LUFTFARTSDIREKTORATET
Ave. for Luftfartsinspeksjon
FORNEBU-OSLO/Dep.
Tlf.: Oslo 1021 12 13 14
Aftl.: ENFRYA
Tegn.: CI/ALAK OSLO
Telex: 11022 Oslo

LUFTDYKTIGHETSPÅBUD

CONTINENTAL

SAMMENDRAG

FIGURE 1

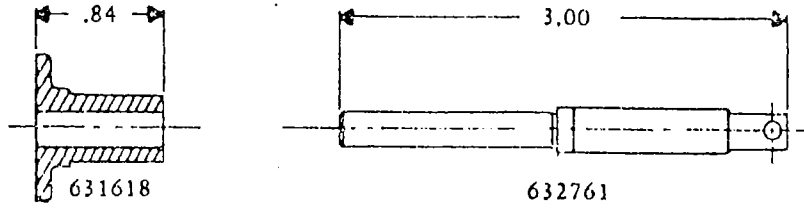
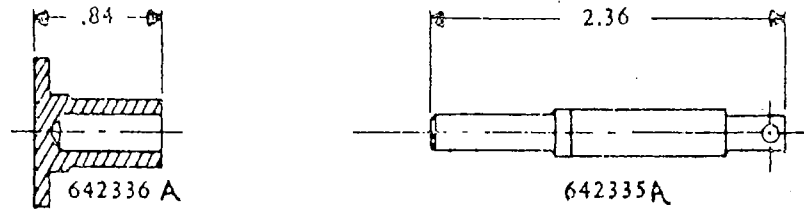
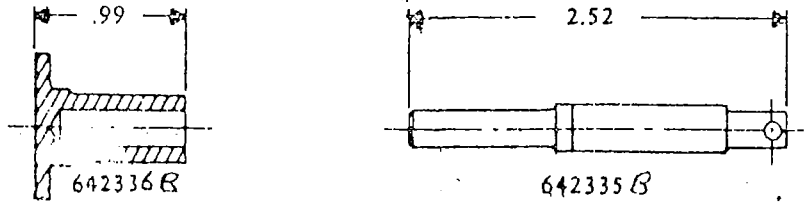
ORIGINAL DESIGN

INTERMEDIATE DESIGN

CURRENT DESIGN

Figure 1.

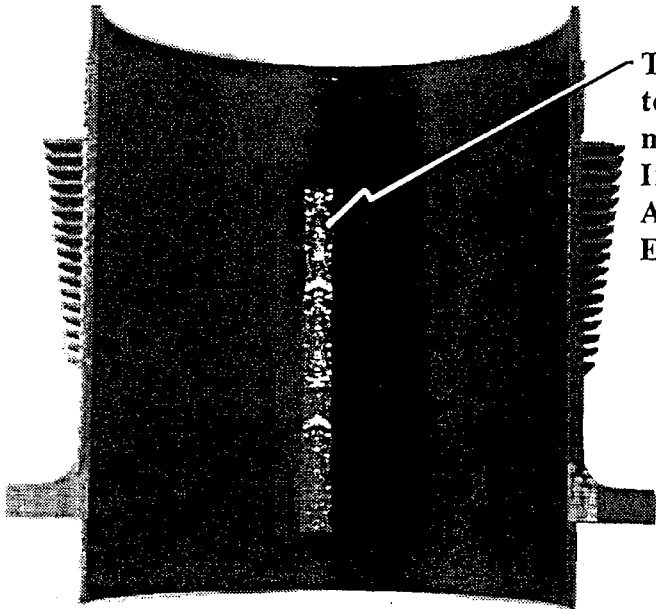
Typical Manganese Phosphate Cylinder Bore Surface Appearance

Figure 2.

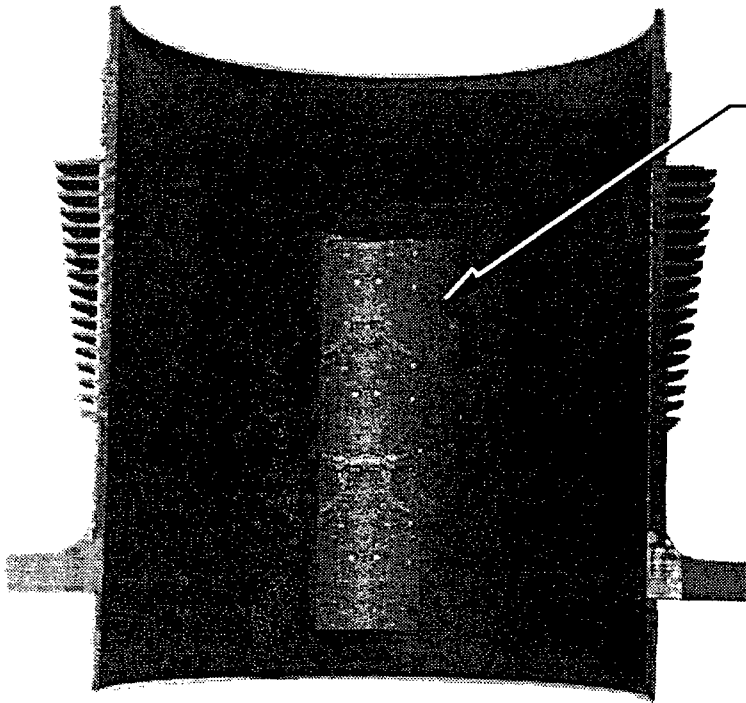
This Type Of Narrow Wear Pattern Is Normal. Cylinder Removal Is Not Required Unless Indicated By Results Of Oil Analysis Or Oil Filter/Screen Examination.

Figure 3.

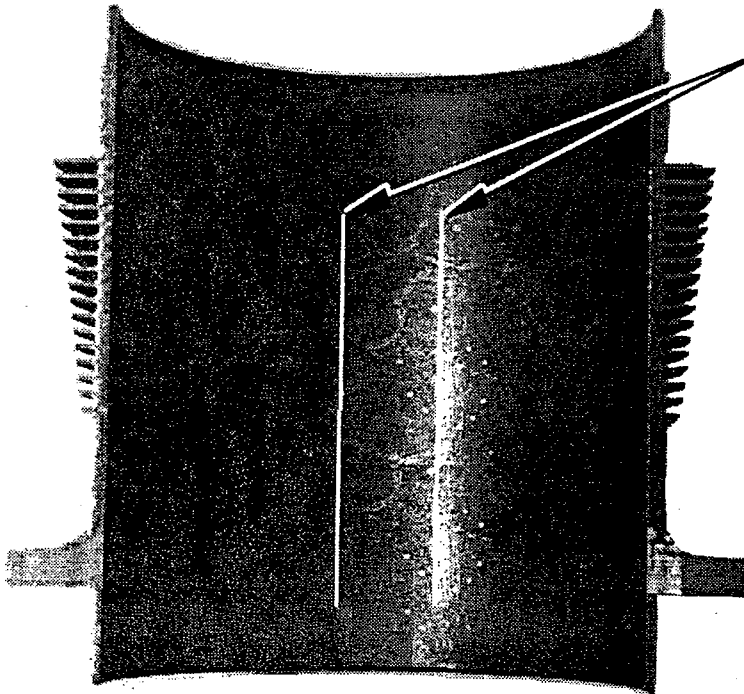
Any Cylinder Bore That Exhibits This Type Of Wide Wear Pattern Must Be Removed For Inspection.
